RSB 575
March 25, 2022

NHTSA #22V 043
TC #2022-035

RECALL SERVICE BULLETIN

Valve Stem Extension and Stabilizer Work Instructions

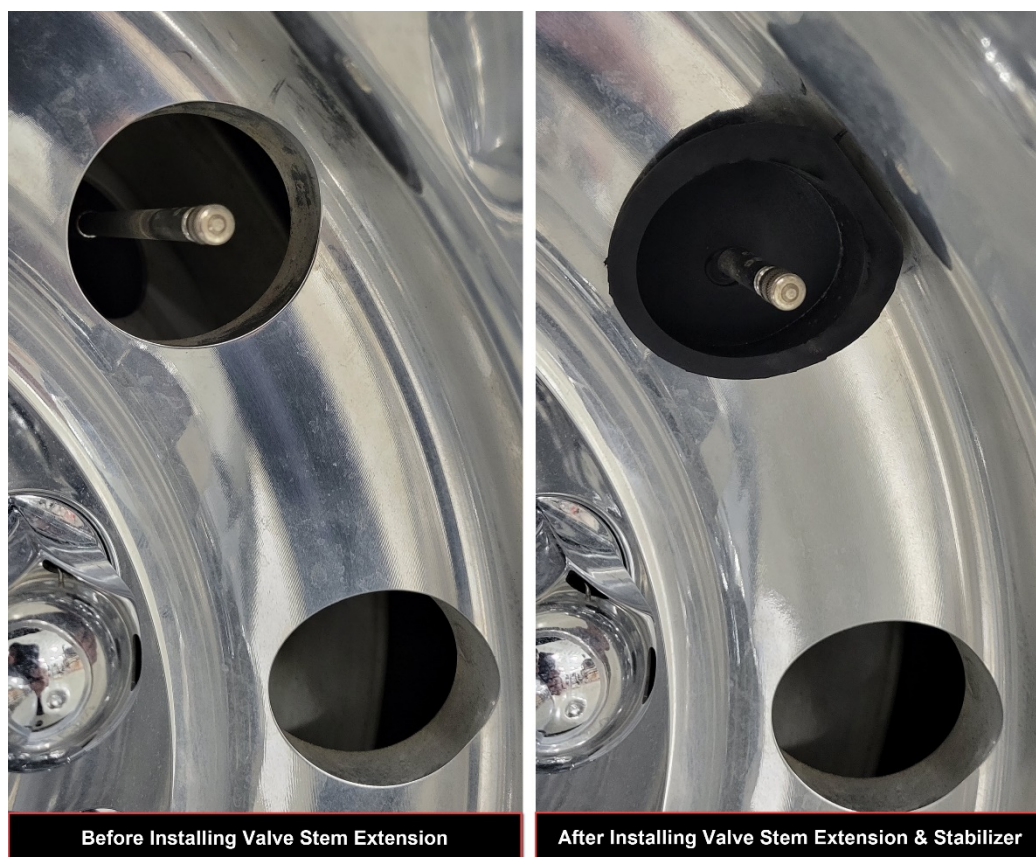
Take pictures of the original valve stem extension installed, then remove the valve stem extension. Be sure to note any damage to the valve stem or valve stem extension (with picture). Install the new valve stem extension.

If no leaks are detected, install the rubber stabilizer by putting the valve stem extension through the center hole. Then push the stabilizer into the rim with the flat side toward the dish of the rim and away from the lug nuts.

If the customer had aftermarket TPMS sensors installed on a Super Star coach on the valve stem extensions, reinstall them and use a jamb nut to lock them in place (if used), and spray the TPMS sensor with the bubble solution to ensure no leaks are present at the TPMS sensor.

Take pictures of new stabilizers and valve stem extensions installed.

Submit before and after pictures when submitting the claim to Newmar.
